**Re: Docket LC 78 - In the Matter of Idaho Power Company's 2021 Integrated Resource Plan ("IRP").**

**ERRATA TO IDAHO POWER  
COMPANY'S REPLY COMMENTS**

**Originally Filed: August 4, 2022**

**Errata Filed: August 16, 2022**

1 **Figure 1 Weather-Adjusted Sales by Class to Gross State Product (“GSP”)**

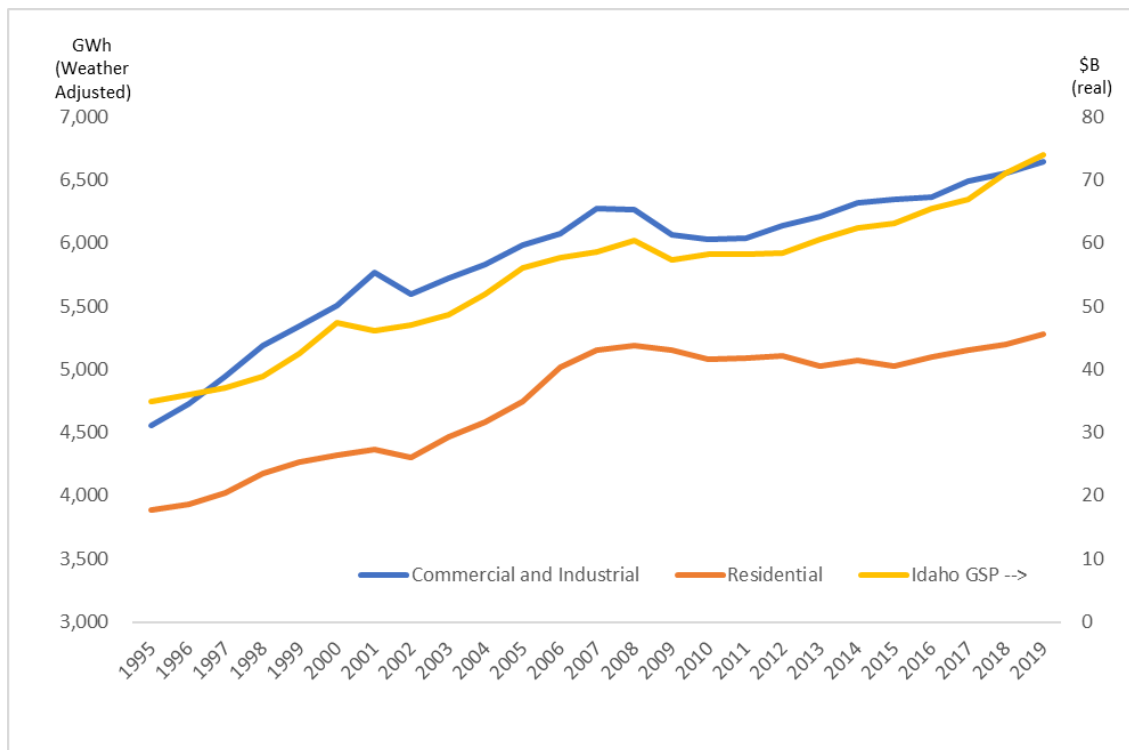
14 With respect to the residential load forecast growth rate, Staff notes that Idaho Power's  
15 time series only goes back to 2011.<sup>14</sup> Staff believes this regression model should be tested  
16 against longer time periods.<sup>15</sup> Staff's Request for Company Reply Comments 2 and 3 ask the  
17 Company to explain how the problem of autocorrelation was resolved in Idaho Power's regression  
18 model for residential customers and why the data for residential regression model only goes back  
19 to 2011. Further, Staff asks why this same reasoning, of training periods beginning in 2011, does  
20 not apply to the regression models with longer time periods of historical data.<sup>16</sup>

16         Figure 1 below shows a comparison of Gross State Product for Idaho and the annual  
17 weather-adjusted energy sales for residential and commercial and industrial sectors. Starting in  
18 2011, growth in the economic output for the state continues to show a strong correlation with the  
19 commercial and industrial sectors, whereas a shift in the correlation appears to exist for the  
20 residential sector.

7 **Figure 2 Mid-C Hub Average Forward Prices \$/MWh vs AURORA Planning Conditions**

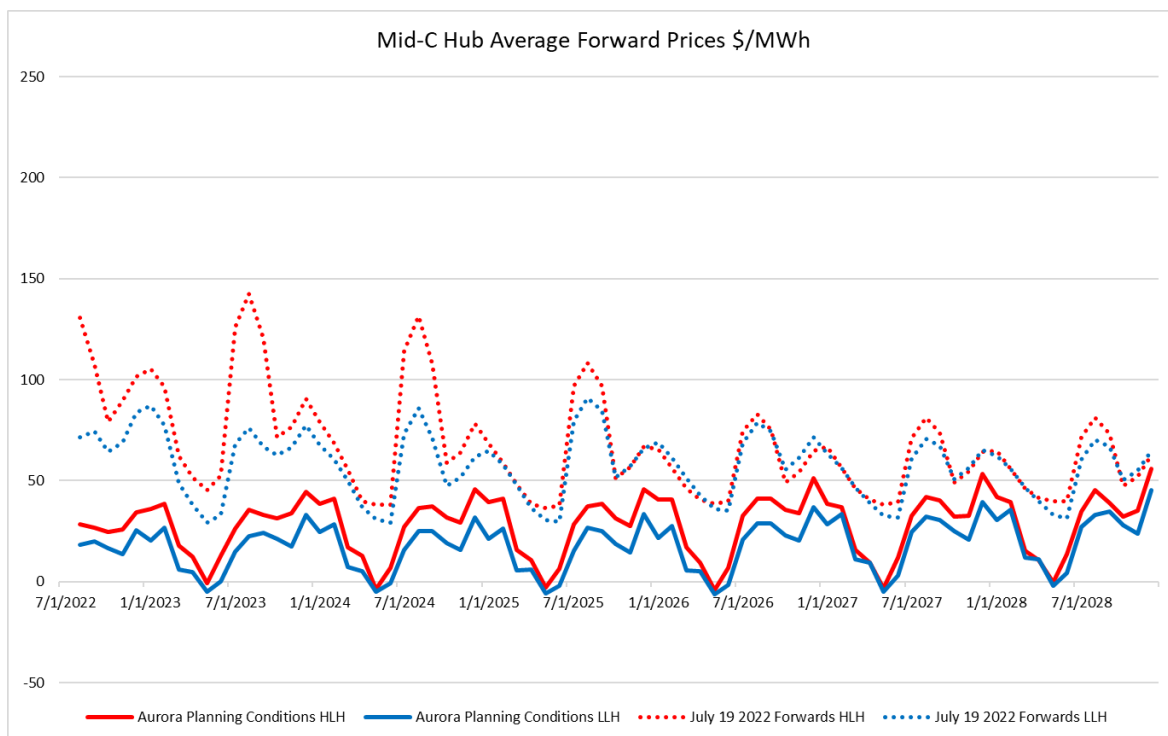
19 Because Idaho Power’s AURORA-based Mid-C forecast is significantly lower than the  
20 prices the Company uses to set Public Utility Regulatory Policies Act (“PURPA”) prices in  
21 UM 1730,<sup>68</sup> Staff’s Request for Company Reply Comments 14 is for the Company to graph the  
22 2021 IRP’s Mid-C and Palo Verde forecasts with the latest forward price curves of these markets

3 Forward price curves are ever evolving and, as such, today's observable forward market  
4 prices were not available at the time the 2021 IRP was developed. Nevertheless, Figures 2 and  
5 3 show the latest price curves (circa July 19, 2022) graphed against the planning condition prices  
6 from the AURORA model for Mid-C and Palo Verde.
